**Report of the Committee on
Forest and Rural Fire Protection**

The Technical Committee on **Forest and Rural Fire Protection** is presenting two Reports for adoption, as follows:

Report II: The Technical Committee proposes for adoption, a complete revision to NFPA 1144, **Standard for Protection of Life and Property from Wildfire** 2002 edition. NFPA 1144 is published in Volume 11 of the 2006 National Fire Codes and in separate pamphlet form.

1144-1 Log #CP2 **Final Action: Accept**
(Entire Document)

EXHIBIT 18.3 Minimum turning path for single unit truck design vehicle. (Courtesy of A Policy on Geometric Design of Highways and Streets by the American Association of State Highway and Transportation Officials (AASHTO))

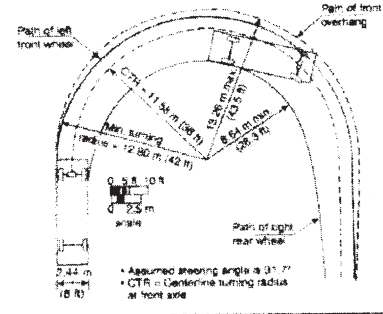
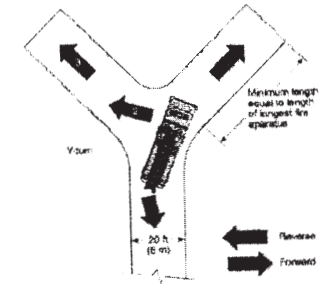
Submitter: Jon Nisja, Northcentral Regional Fire Code Development Committee
Recommendation: Delete existing exhibit and replace with the following:

Substantiation: These exhibits are a little better illustrations than what’s presently in use in the appendix and again brings both standards in line.
Committee Meeting Action: Reject
Committee Statement: The Committee has refocused the scope and the intent of the document to identify and mitigate factors that could cause the ignition of structures from exposure to wildland fires. As a result, the document addresses site specific attributes of structures and their ignition zones. The broader scale infrastructure elements for fire protection are addressed in a revised and refocused NFPA 1141.
Number Eligible to Vote: 22
Ballot Results: Affirmative: 21
Ballot Not Returned: 1 Spitzer, Jr., H.
